ELECTRO INDUSTRIES - FIELD SERVICE BULLETIN

Bulletin Number: 1118 – (Supersedes – 1115)

Product Name WarmFlo II Plenum Heaters

Affected Product Model Numbers: EM-WU***5*, EM-WD***5*

Figure 1

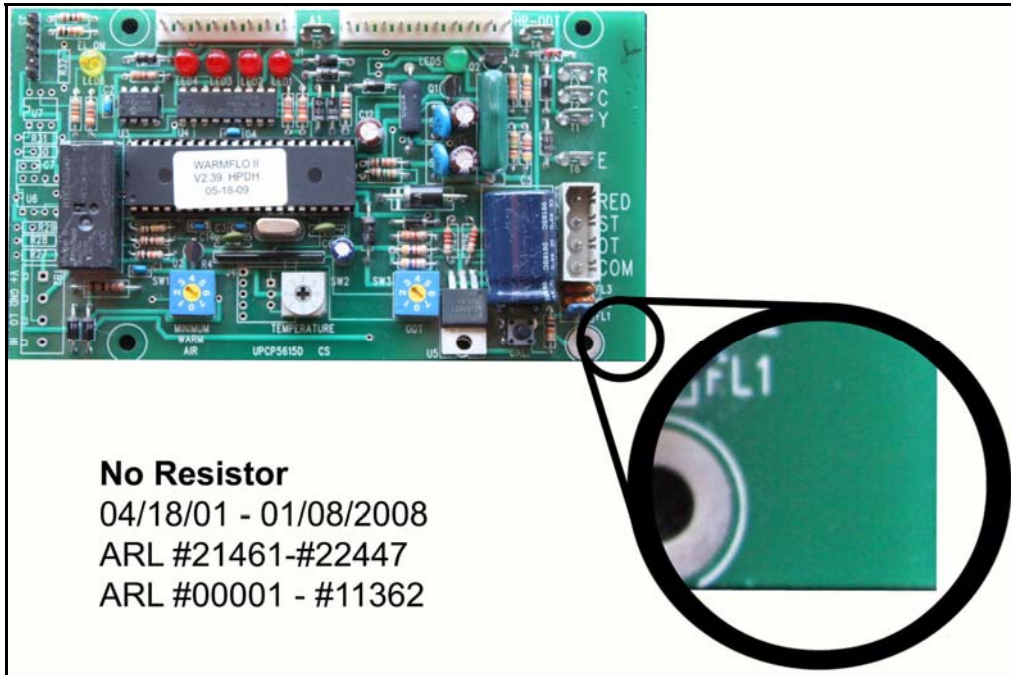
Control boards that do **not** have a resistor as shown under **Figure 1** are not affected by this issue and will not be covered under this Field Service Bulletin. If your plenum heater is displaying the symptoms above, and includes a 1K resistor as shown under **Figure 2**, your control board will be covered under this Field Service Bulletin. Control boards that have a zero Ohm resistor as shown under **Figure 3** are the latest version of this control board. This version is not affected and will not be covered under this Field Service Bulletin.

Figure 3

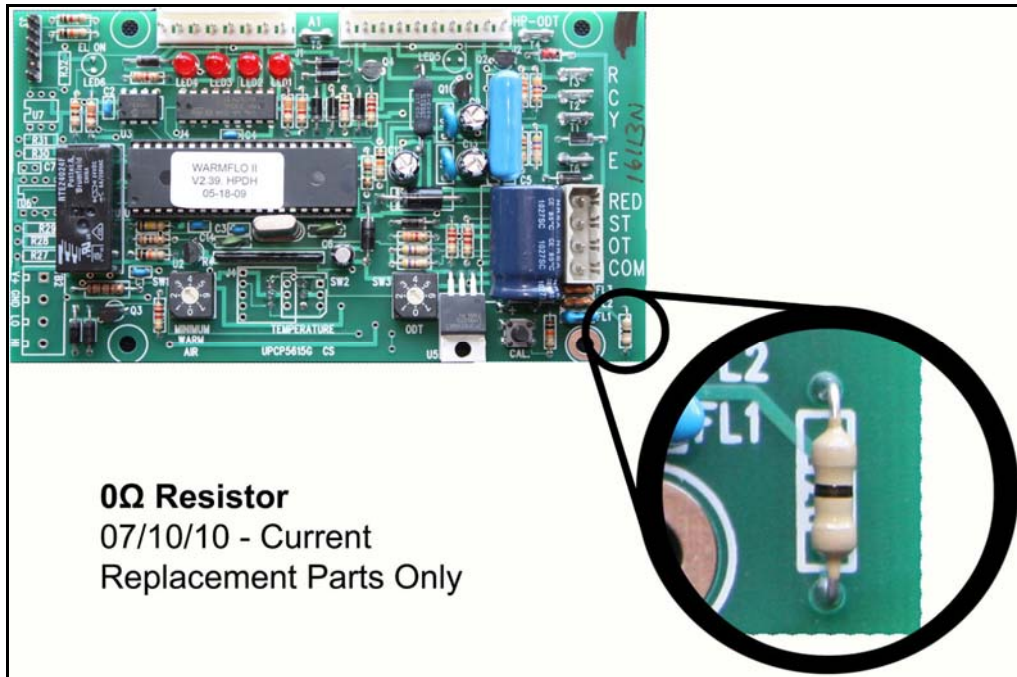
0Ω Resistor
07/10/10 - Current
Replacement Parts Only

- Replacement part number: WF2EM
 - Specify V2.39 when ordering along with the chip code, such as HPDCH, HPHF, EMW, or EMA. The chip code is located on the white label affixed to the microprocessor chip itself.
